## INVENTORY No. 024

**LOCATION:** Main Office Building

**EQUIPMENT:** Panel LRMA Main Disconnect  
Right Phase Top Fuse Holder

**Thermal Infrared Exception Photo**

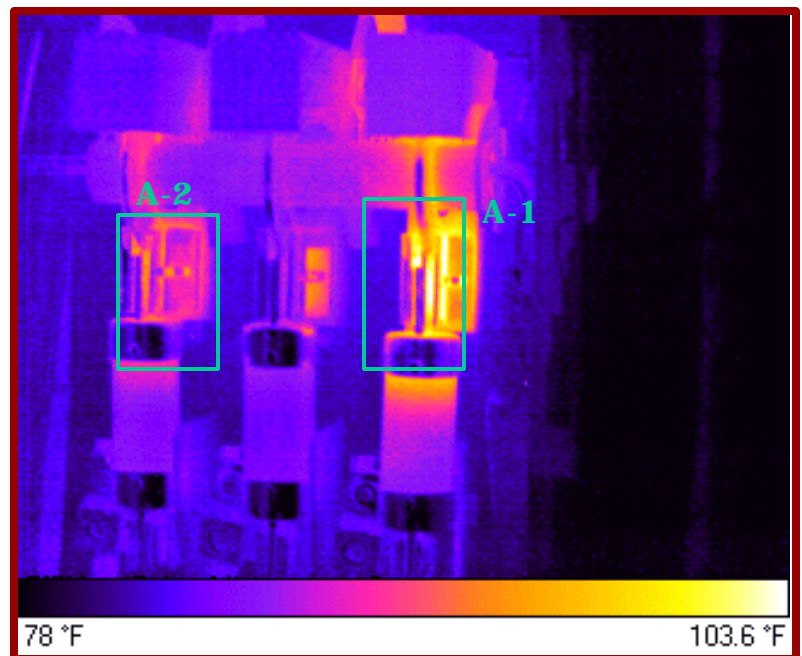
**FINDINGS:** Suspect loose deteriorated fuse holder components and contacts.

**EXCEPTION TEMP. (Area.1):** 107F

**REFERENCE TEMP. (Area 2):** 85F

**DELTA-T:** 22F

**PRIORITY 2**

**RECOMMENDATIONS:** Inspect, clean, and tighten fuse assembly and related components. Replace fuse and components if required.
